| P. O<br>Telecomms  | ISSUE |            |   |                   |            |

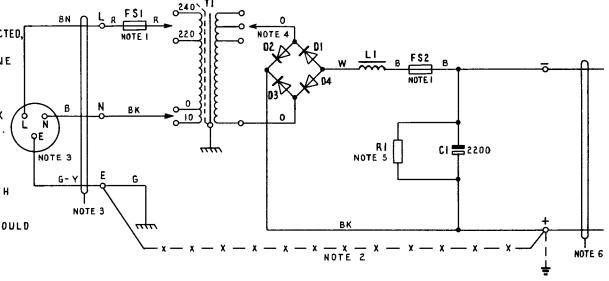
| P. O<br>Telecomms  | ISSUE |            |   |                   |            |
|--------------------|-------|------------|---|-------------------|------------|
| HQRS.<br>PAPER:- W |       | -si I      | NEW FORMAT. TRANSFORMER 2009 TAPPING REMOVED.W<br>CAPACITOR VALUE CHANGED. NOTES 2&3 AMENDED.NOTE 6 W | AS NOTE 4. NOTE 4 | 23-1-78    |
| DISTN:-<br>GENERAL |       | <u> </u> _ | ADDED. + VE OUTPUT WIRE WAS R, - VE OUTPUT WIRE WAS BK. D.  | L.W. T07-2-3      |            |
|                    |       | D          | EARTH WIRE SPECIFIED  | KMA               | 7 · 3 · 68 |
